Re: 49 CFR Part 573.6; Recall of Mercedes-Benz C-Class (204) Rear Outboard Seatbelts

Re: Recall Campaign 2007100002- Replace Rear Outboard Seat Belts Model 204, Model Year 2008

Campaign No. 2007100002, November 2007

SUBJECT: **MODEL 204, MODEL YEAR 2008**
REPLACE REAR OUTBOARD SEAT BELTS

Figure 1

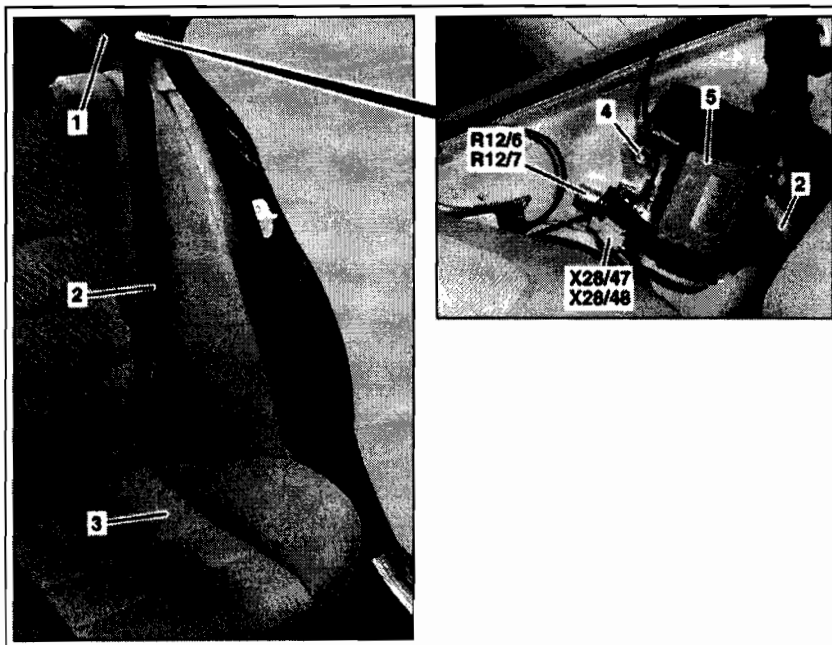
1. Disconnect battery ground cable, refer to WIS: AR54.10-P-0003CW.
2. Remove left C-pillar paneling (1, Figure 1), refer to WIS: AR68.30-P-4490CW.

Refer to WIS: AR68.30-P-4490CW to remove the C-pillar paneling (1, Figure 1), seat cushion (3, Figure 1) and the lower mounting bolt.

3. Disconnect left rear emergency tensioning retractor squib electrical connector (X28/47, Figure 1) from left rear emergency tensioning retractor squib (R12/6).

X28/48 (Figure 1):

4. Remove bolt (4, Figure 1) from automatic belt retractor (5) and remove automatic belt retractor (5).

When installing new seat belt retractor, torque bolt to 32 Nm.

- Observe proper installation for right and left versions of automatic belt retractors (5) to proper side of vehicle.
 - Ensure seat belt (2) is not twisted during installation.
 - Ensure tab on automatic belt retractor (5) is correctly inserted into C-pillar.
 - Seat belt will not extend unless the retractor (5) is mounted to the C-pillar (requires proper "X" "Y" axis for operation).
6. Repeat procedure on opposite side.
 7. Check SRS system with SDS then read out and erase DTC's, refer to WIS: AD00.00-P-2000-04A.
